A-40

This is in response to your letter dated May 11, 1981, requesting on behalf of Mr. Thomas Applegate that I recommend suspension of the construction permit for the William H. Zimmer Nuclear Power Station. The request was based on a study by your organization of the NRC's reports of inspections and investigations since early 1979, as well as on allegations made by Mr. Applegate and others.

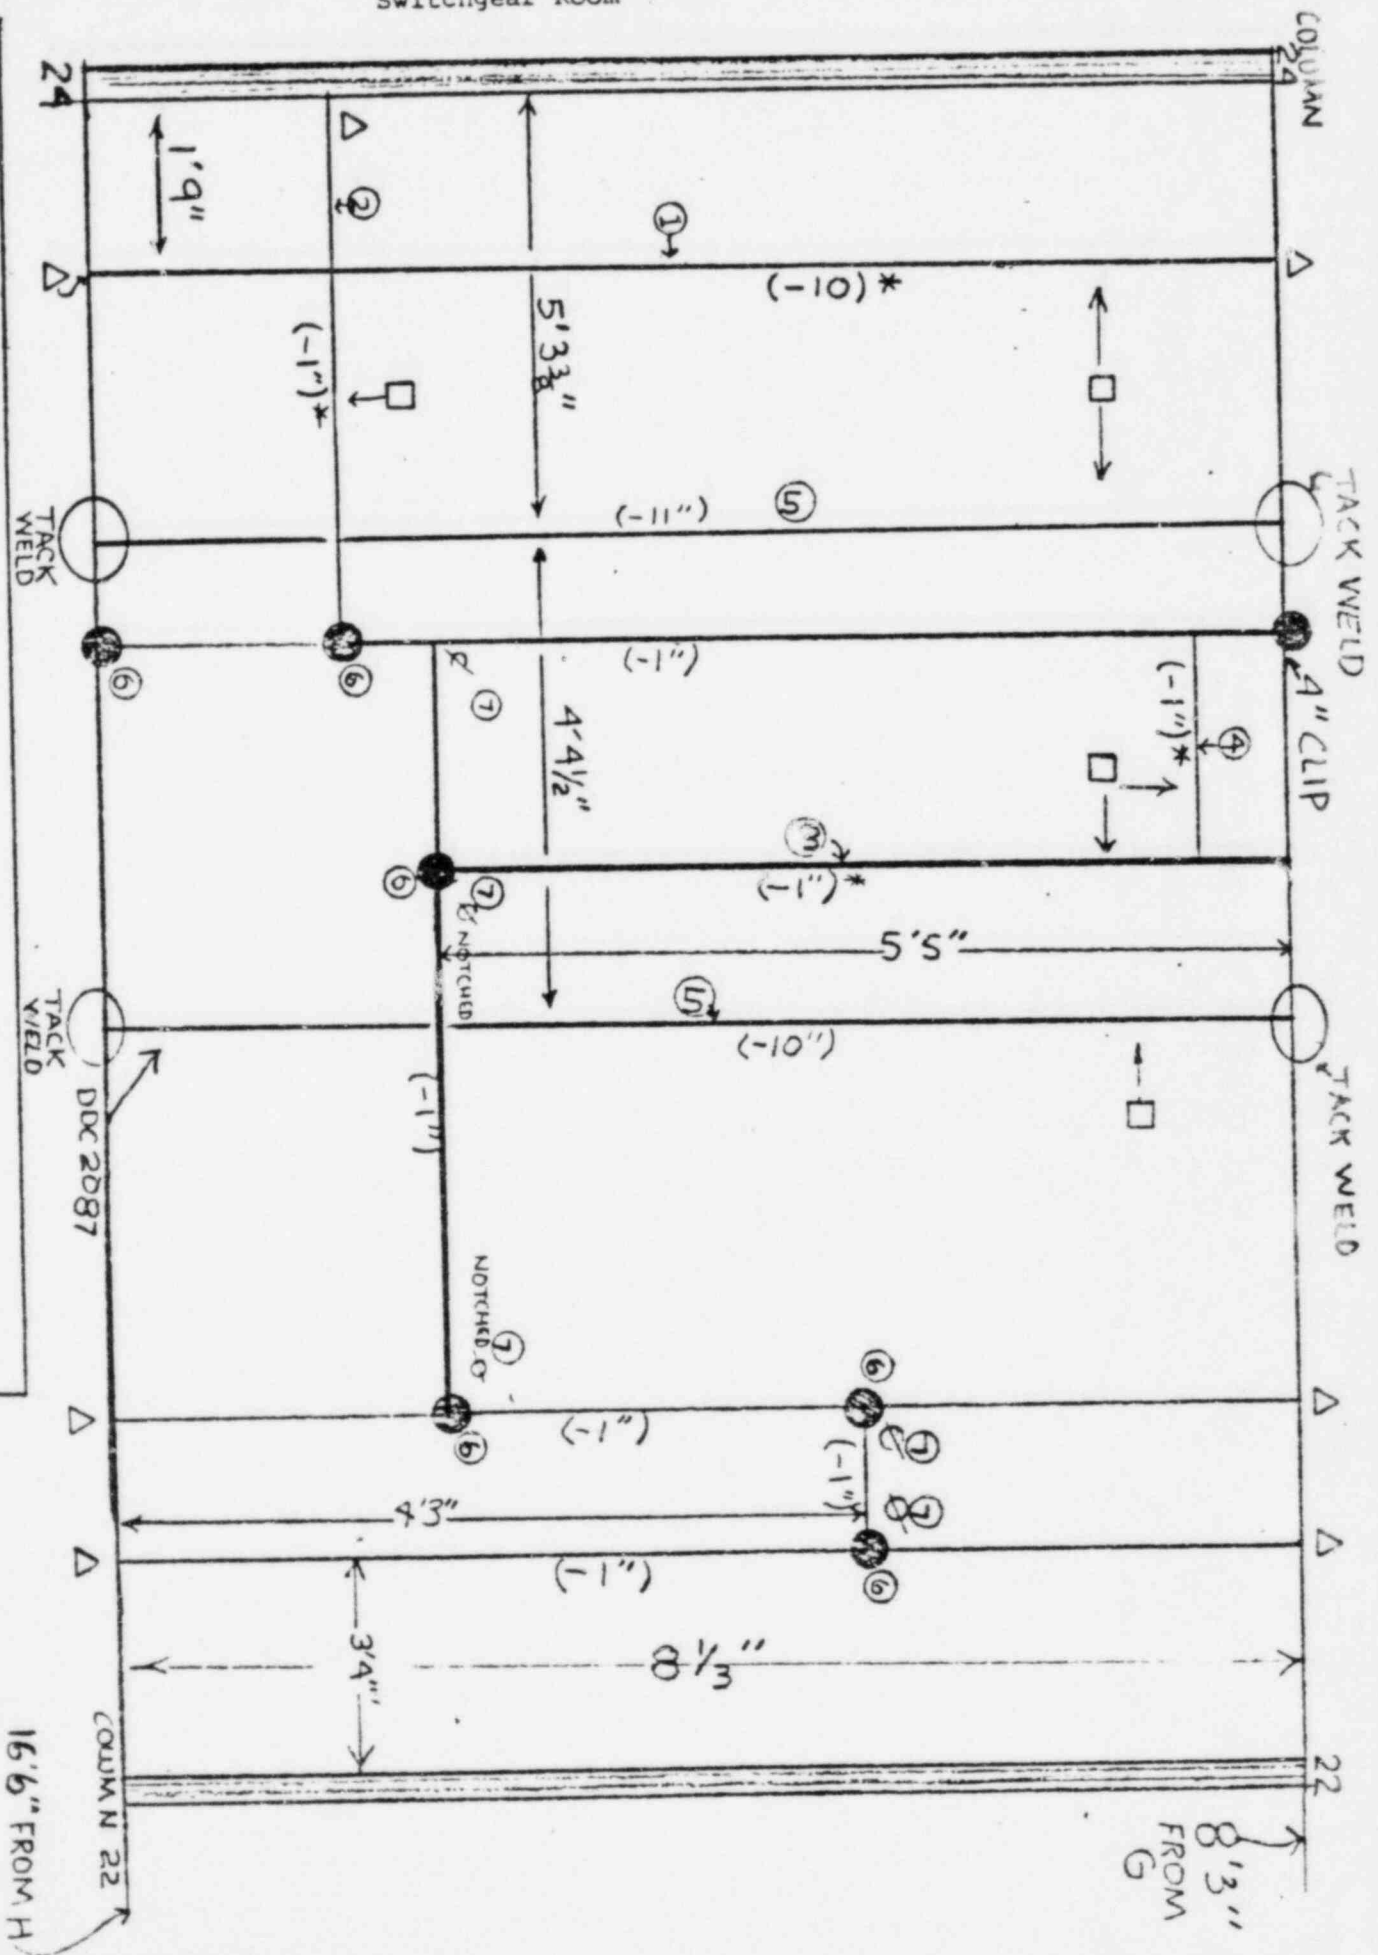
The RIII inspector reviewed the Bristol Quality Control Steel Erection Report Inspection Report Q-7, dated July 14, 1975, for the inspection of the beams installed on elevation 546 ft between column rows 15-22 and F-L.

~~also~~ The ~~inspector~~ ^{inspector} determined that the Bristol Steel and Iron Works, Inc. QC inspector failed to document details of his inspections such as the welding materials (rod type) used, the welder, the specific weld activities inspected, and/or bolting ~~or~~ or welding procedure number when applicable.

This is con-

trary to 10 CFR 50, Appendix B, Criterion XVII and the Wm. H. Zimmer QA Manual, Section 17.1.1. (358/81-13-52)

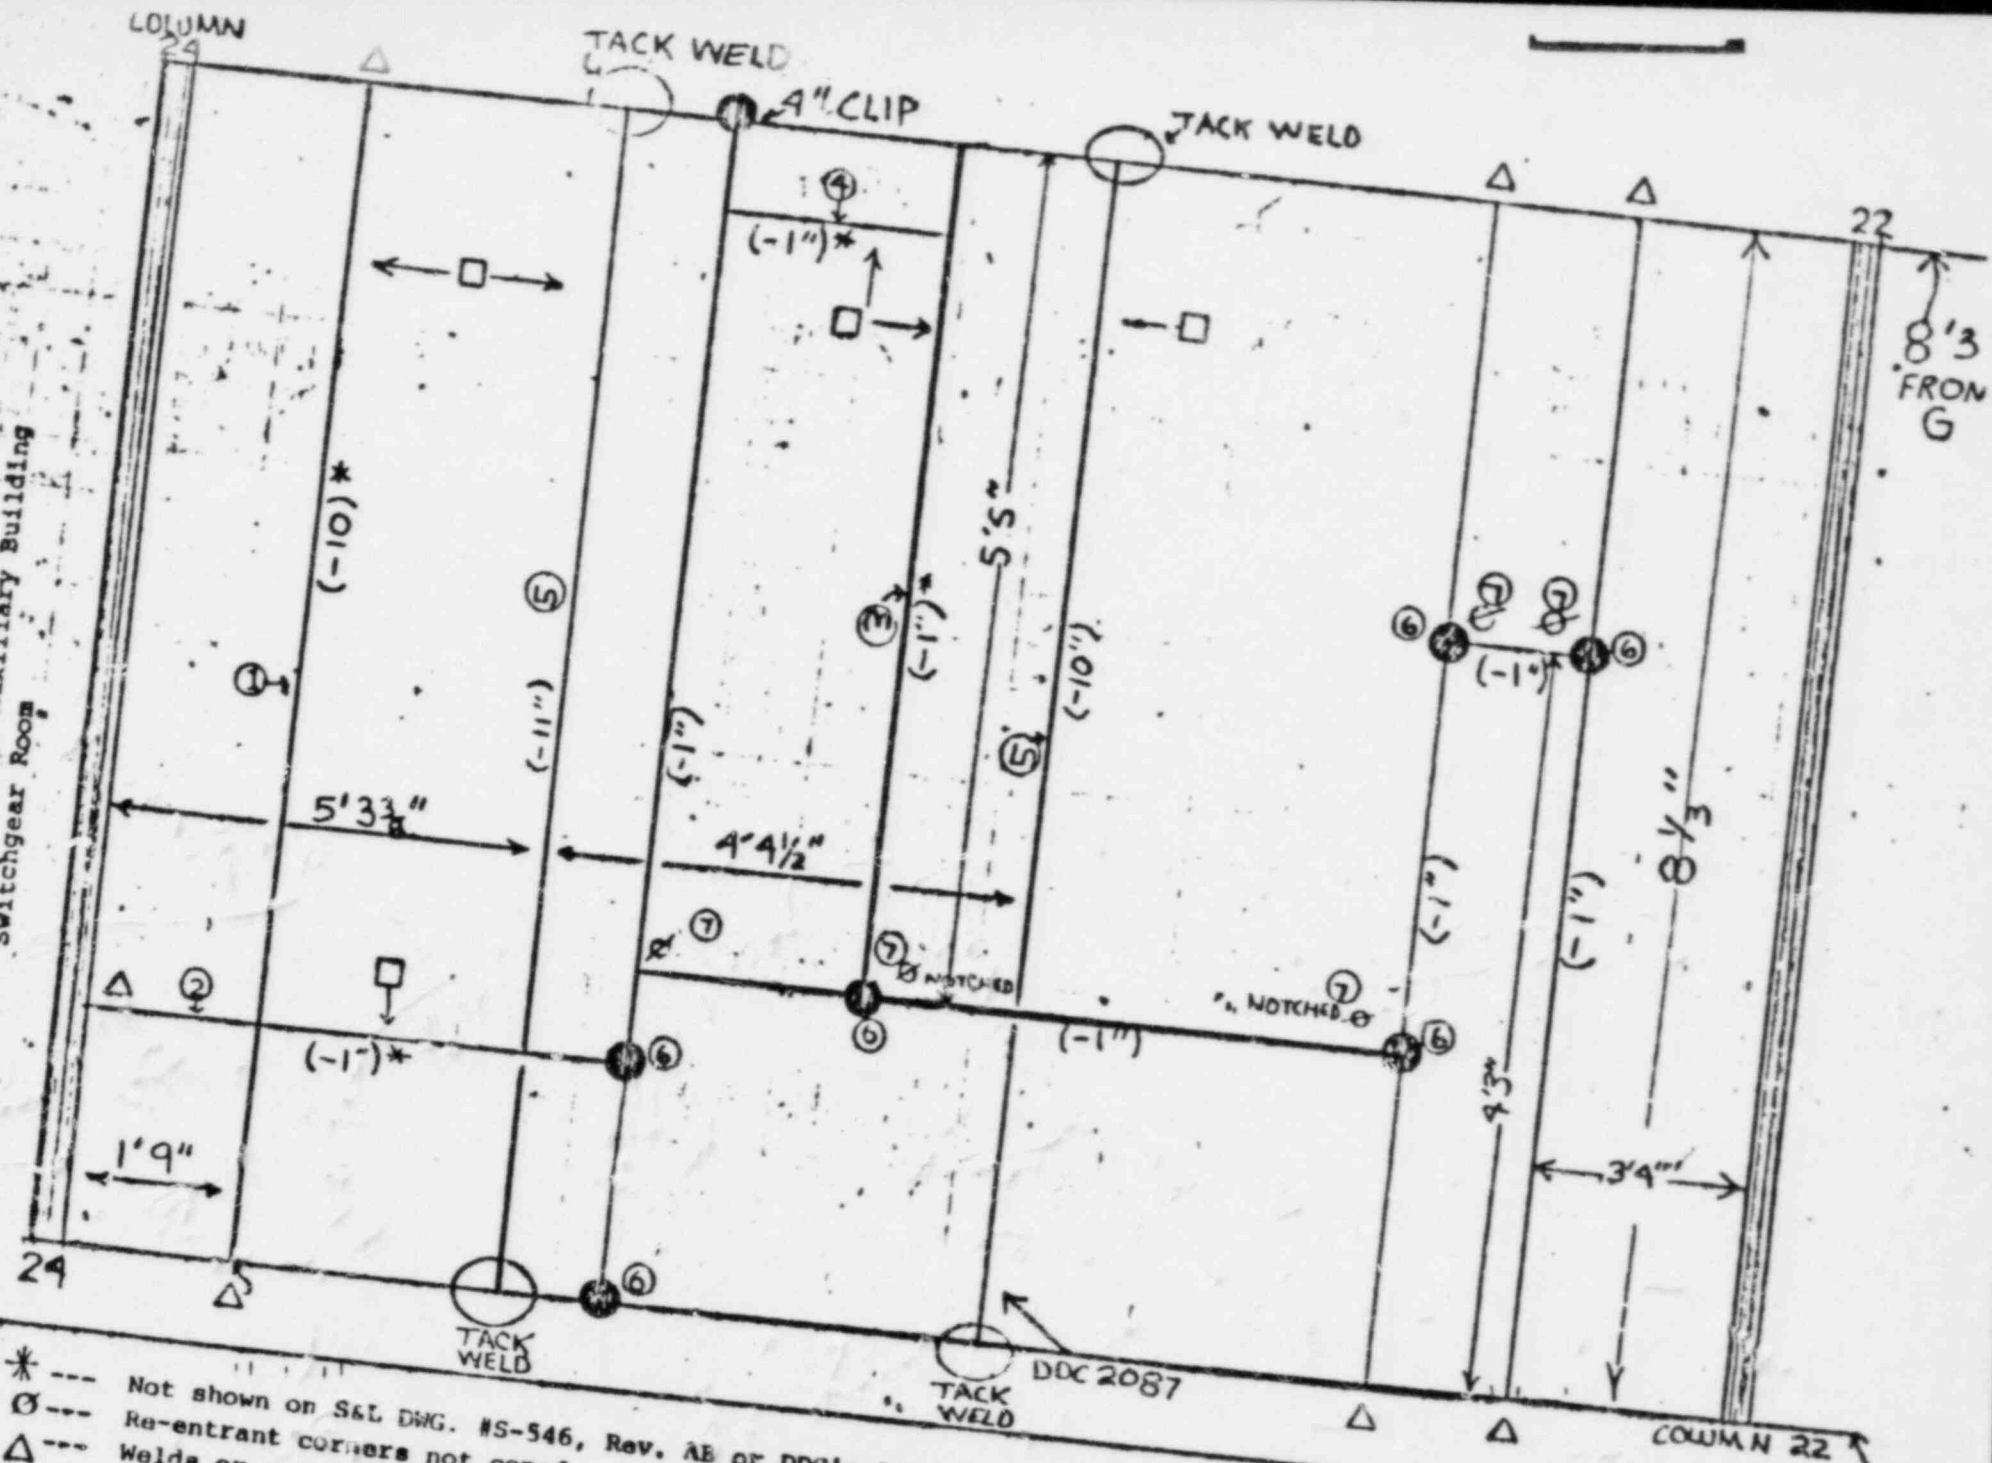
For the beams addressed in paragraphs 1.a.(1) and 1.b.(4) above, no measures existed for DDCs which would identify to QA, kinstallations and work that was done by construction before receiving S&L approval. Thus no measures existed to assure that all of the required QA inspections (e.g. welder qualification, proper filler metal, traceability of materials, etc.) related to DDCs would be accomplished.

This condition was previously identified in IE Report Item No. 80-15-04. The corrective actions, taken in regard to Item No. 80-15-04, did not include the DDCs written prior to the implementation of the corrective actions, and the DDCs that are and have been implemented prior to receiving the S&L approvals.

These inadequate corrective actions are contrary to 10 CFR 50 Appendix B, Criterion XVI and the Wm. H. Zimmer QA Manual, Section 16.5 as described in the Appendix A to the report transmittal letter. (358/81-13-02)

ATTACHMENT A
 WB X 17's - Elevation 546 Auxiliary Building
 Switchgear Room

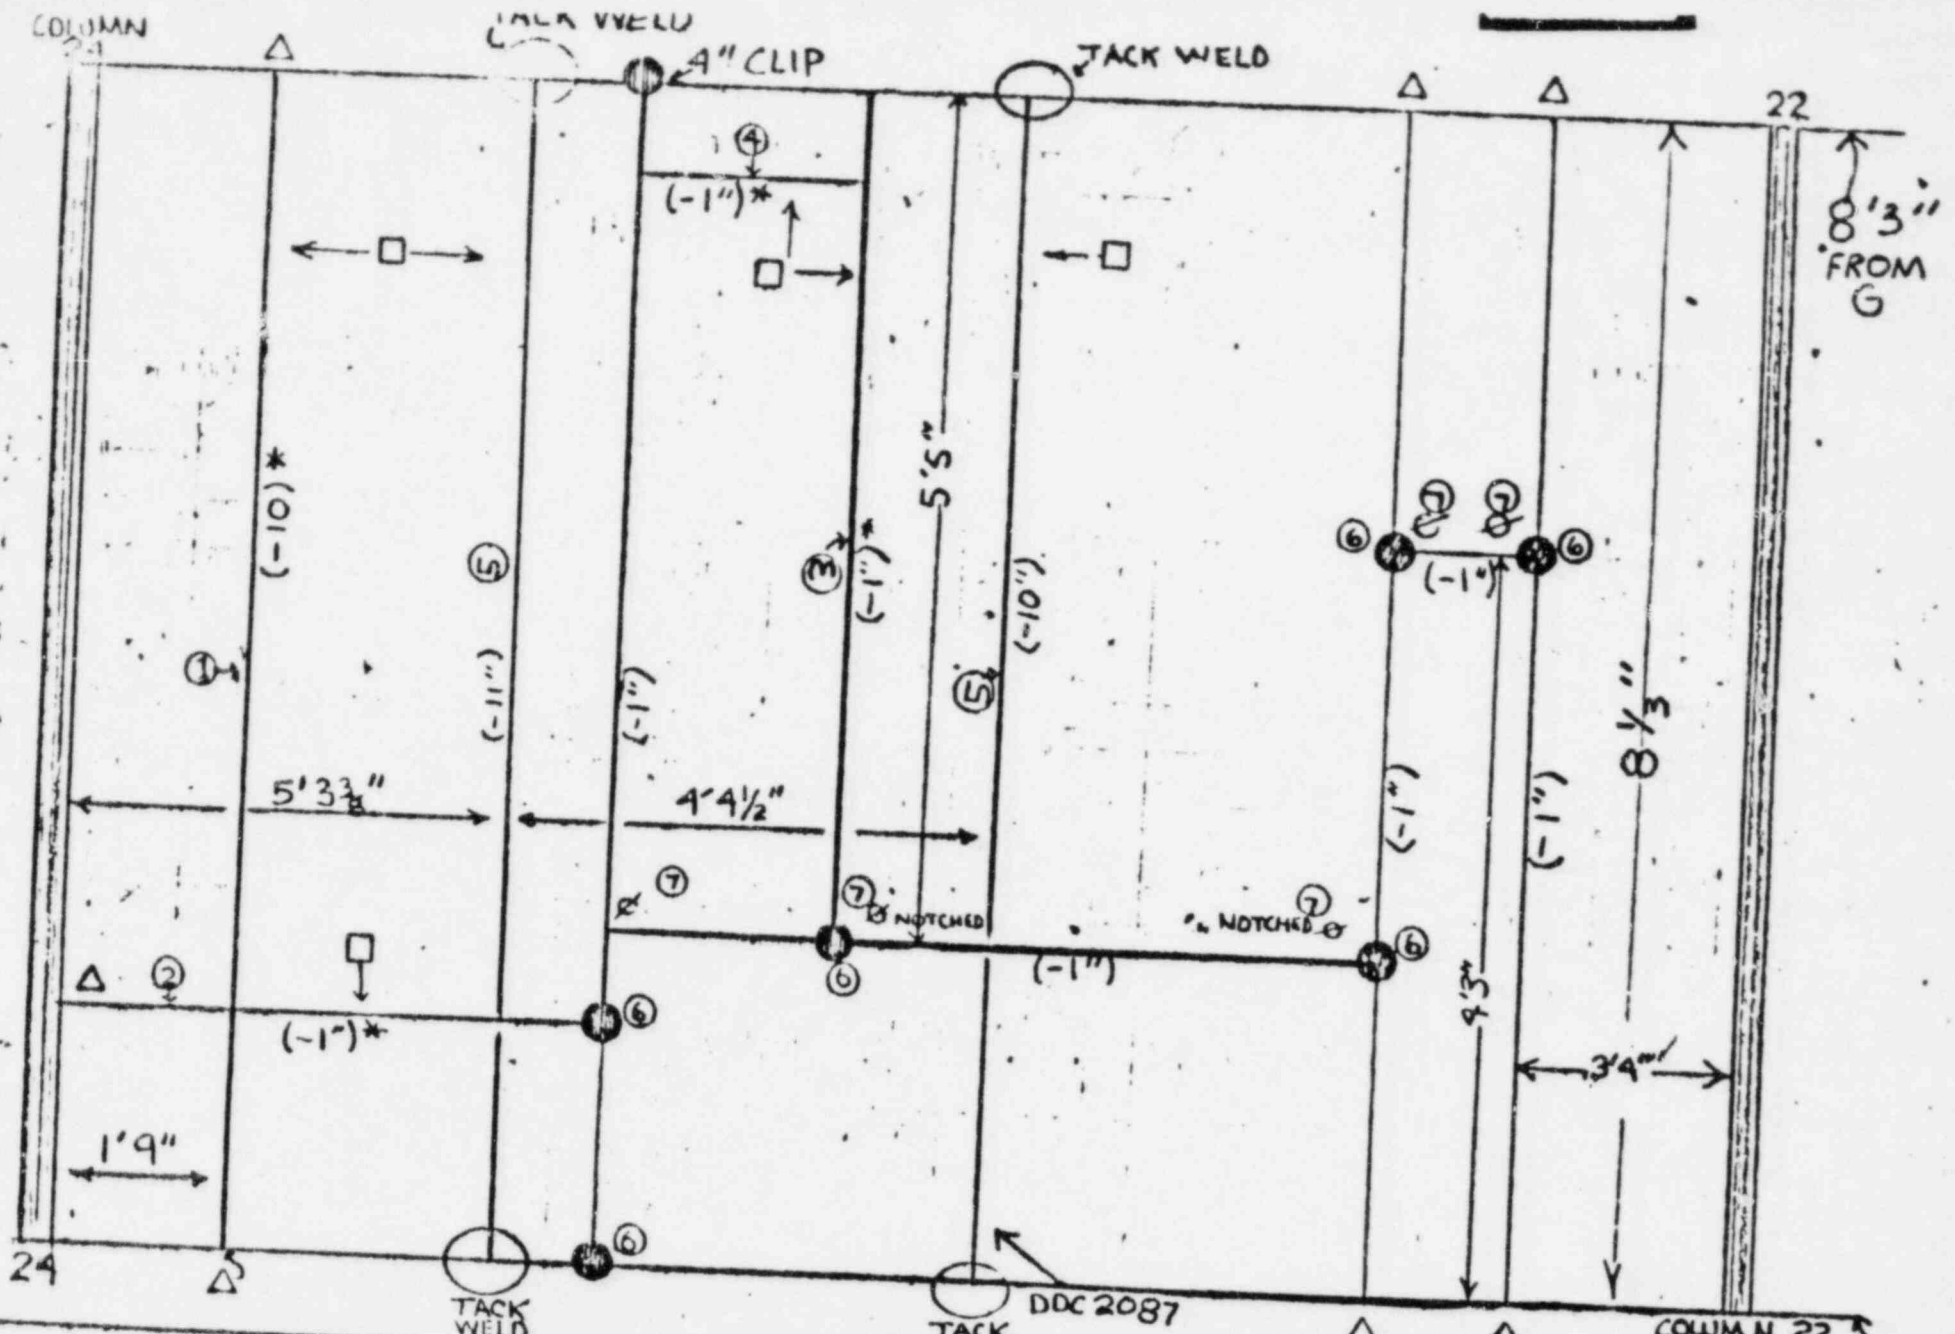
- beams
- (5) Two W8 x 17 ~~e<beams~~ (8 feet 3 inches in length) positioned east to west, one located 5 feet 3 3/8 inches and the other located 9 feet 7 7/8 inches south of column 24, are only tack welded in place; display no identification or heat numbers; and are not documented on a KEI-1 form (weld record) or any other QC control document. The beams were identified on DDC-2087 which was incorporated into S&L drawing S-546 Rev. AB. DDCs and S&L drawings by themselves do not assure QC verification. —??

- * --- Not shown on S&L DWG. #S-546, Rev. AB or DDC's listed.
- ⊙ --- Re-entrant corners not coped.
- △ --- Welds or connections covered with fire proofing unable to evaluate.
- [] --- No identification on WBX17's or records to support tracibility of material
